**BOARD OF ZONING ADJUSTMENT  
STAFF REPORT****Date: August 1, 2016****CASE NUMBER**

6053

Eco-Site (Baker Donelson/Mary Palmer, Agent)

**LOCATION**2617 Dauphin Street  
(Southeast corner of Dauphin Street and the CSX Railroad  
right-of-way)**VARIANCE REQUEST****HEIGHT:** Height Variance to allow a 185' monopole telecommunications tower in a B-3, Community Business District.**SETBACK:** Setback Variance to allow the tower within 17.0' of the lease parcel line.**RESIDENTIAL BUFFER SEPARATION:** Residential Buffer Separation Variance to allow the tower within 34.0' of residentially zoned property.**LANDSCAPING:** Landscaping Variance to allow no site landscaping.**TREE PLANTING:** Tree Planting Variance to allow no tree plantings.**CAMOUFLAGE:** Camouflage Variance to allow no camouflage details on the tower.**ZONING ORDINANCE  
REQUIREMENT****HEIGHT:** The Zoning Ordinance limits structures to a 45' height in a B-3, Community Business District.**SETBACK:** The Zoning Ordinance requires telecommunications towers to be setback the height of the tower (185') from the lease parcel line.**RESIDENTIAL BUFFER SEPARATION:** The Zoning Ordinance requires a residential buffer separation of

# DETAIL SITE PLAN

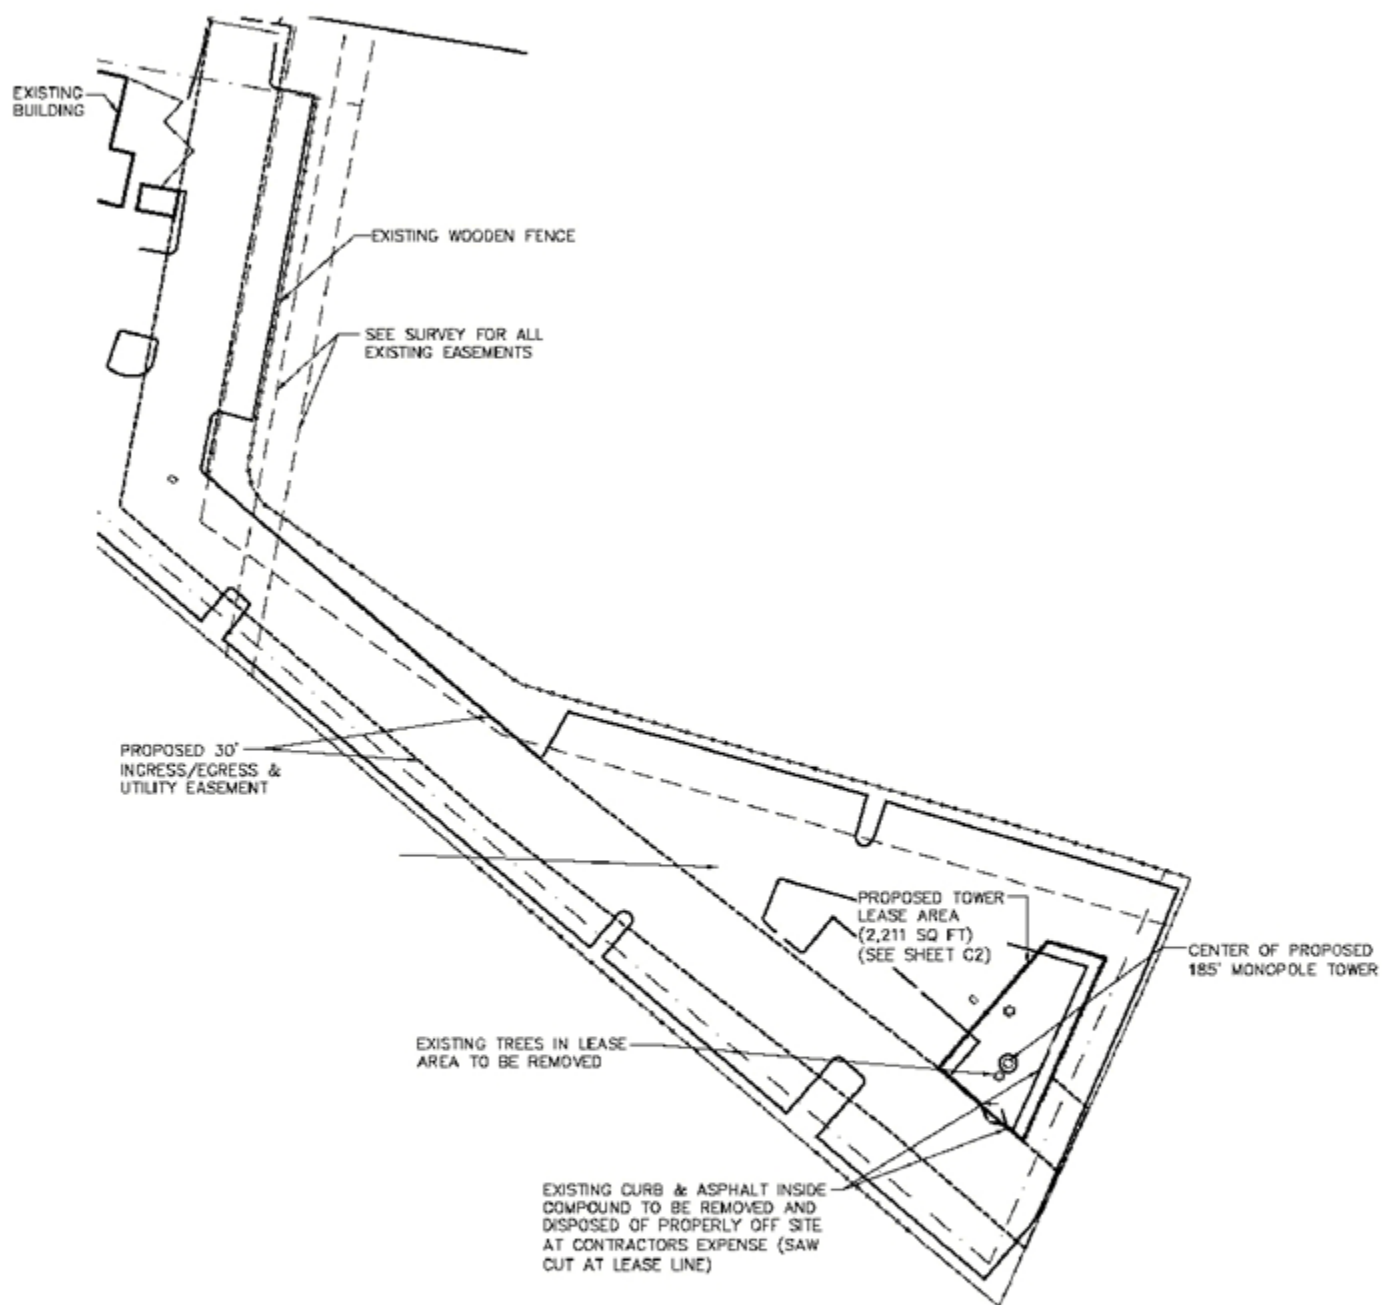
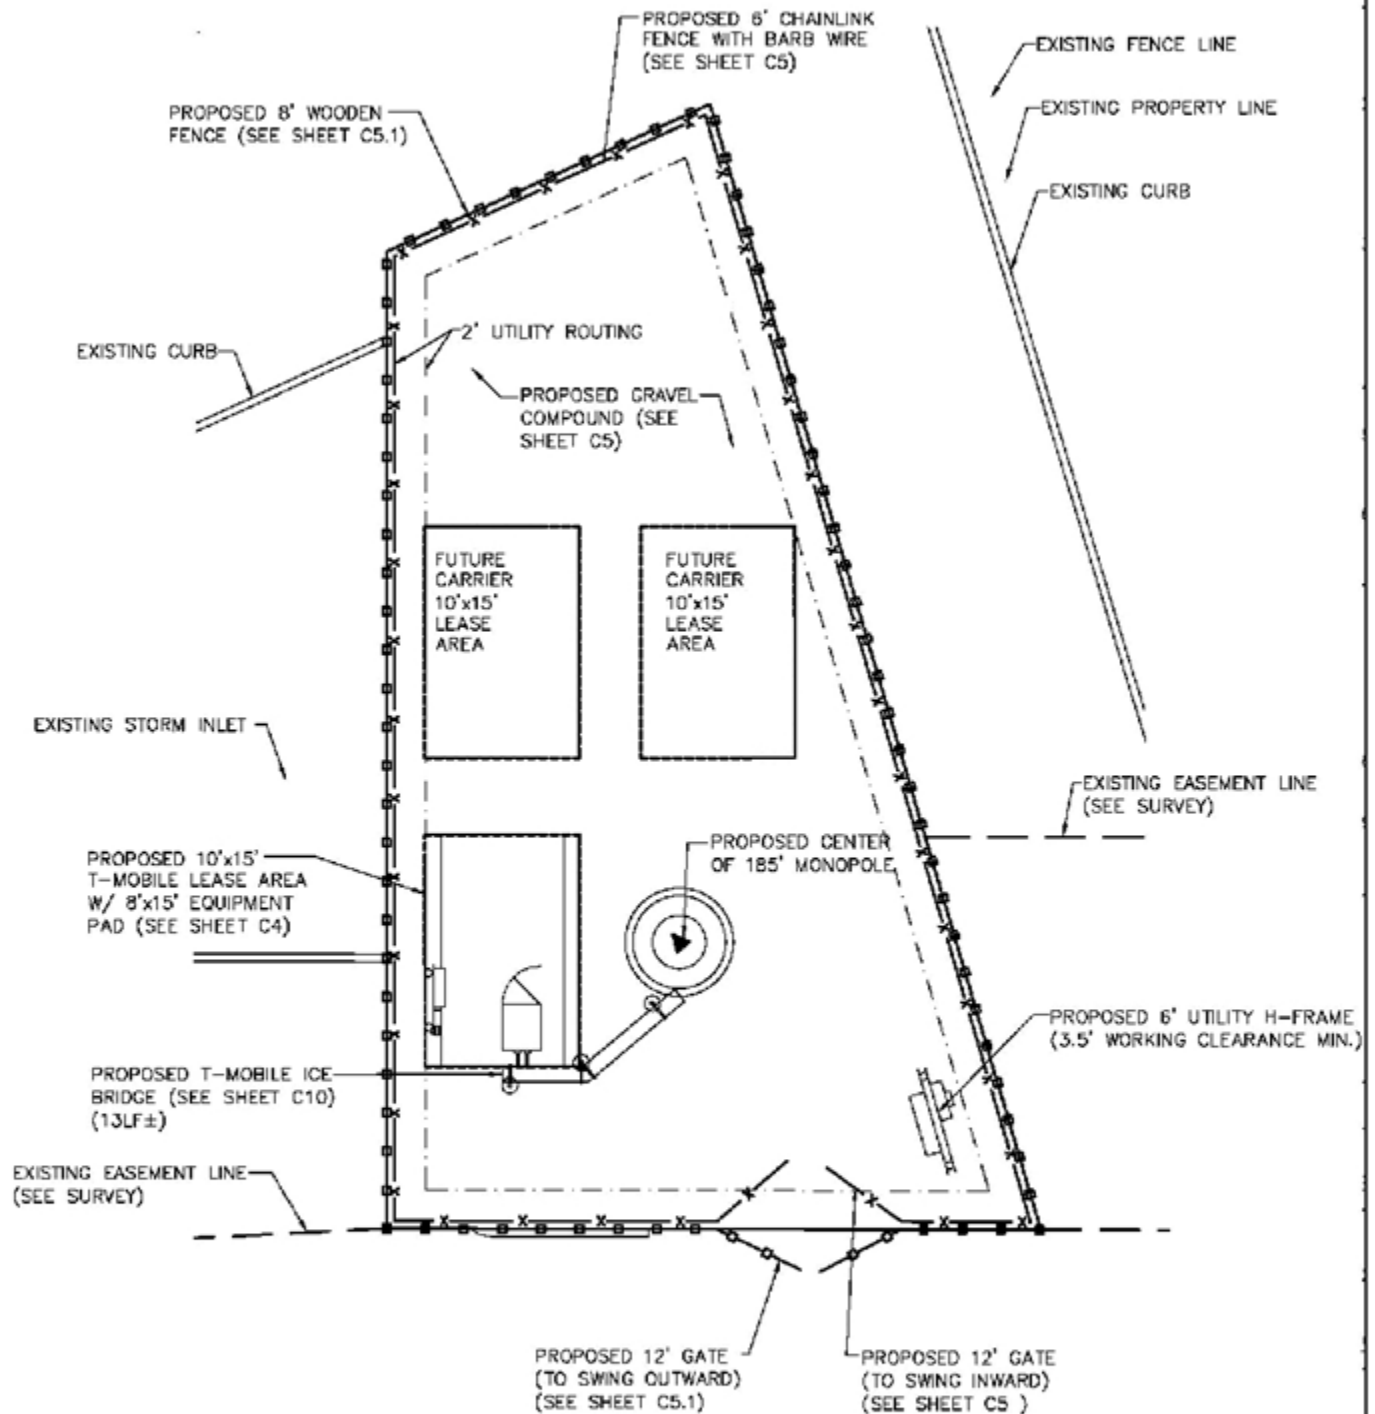
The site plan submitted indicates a 30' ingress/egress and utility easement via a paved parking lot to the tower compound. Also indicated is an 8' high wooden fence along the compound/lease parcel perimeter with a 6' chain link fence topped with barbed wire just inside the wooden fence. However, the applicant has submitted email correspondence indicating that the chain link and barbed wire fence will no longer be placed on the site. If the variances are approved, a revised

site plan indicating the removal of the chain link and barbed wire fence should be submitted to Planning and Zoning.

It should be noted that the site plan references the railroad right-of-way bordering along the South side of the site as under CSX Railroad ownership. The Canadian National Railway (CN) currently operates along that line.

- 5) submission to Planning and Zoning of a revised site plan indicating the removal of the chain link/barbed wire fence within the tower compound;
- 6) subject to the Urban Forestry comments: *[Property to be developed in compliance with state and local laws that pertain to tree preservation and protection on both city and private properties (State Act 2015-116 and City Code Chapters 57 and 64).]*;

- 7) revision of the site plan, if required, to correct the ownership (CN Railway) of the railroad right-of-way along the South border of the site; and

MONOPOLE TOWER ELEVATION

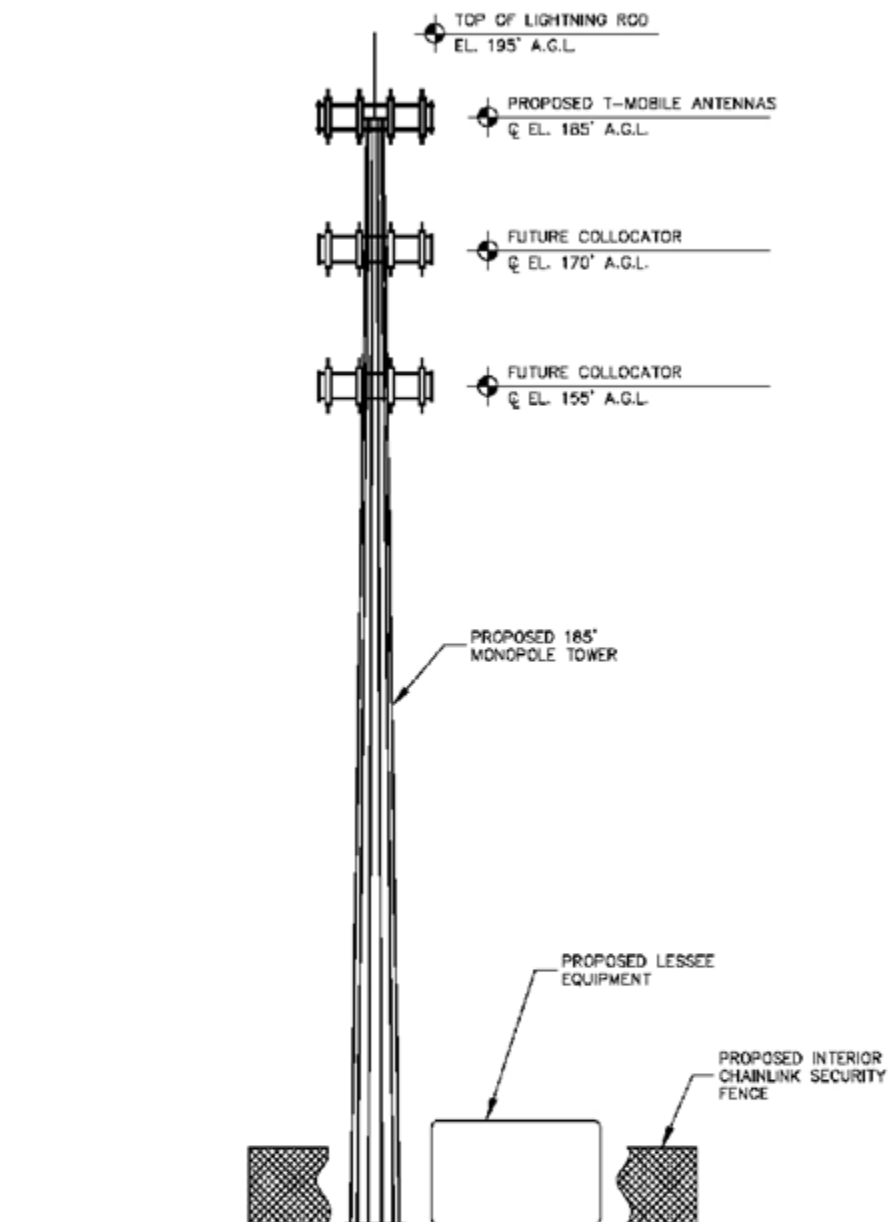
The tower elevation drawing in the application indicates the actual tower height to be 185' but with the antennas extending to an unspecified height above that. The Telecommunications towers and facilities section of the Zoning Ordinance specifies that tower height is determined by the height of the tower structure itself, the base pad, and any other telecommunications facilities attached thereto, and measured from grade. Therefore, as the height requested is 185', the proposed antennas should be lowered so that no portion thereof extends above the 185' top-of-tower structure elevation. A revised tower elevation drawing should be submitted to Planning and Zoning illustrating such.

- 3) removal of the two trees to be permitted by and coordinated with Urban Forestry;
- 4) submission to Planning and Zoning of a revised tower elevation drawing to indicate no portion of the antennas extending above the 185' tower structure height;
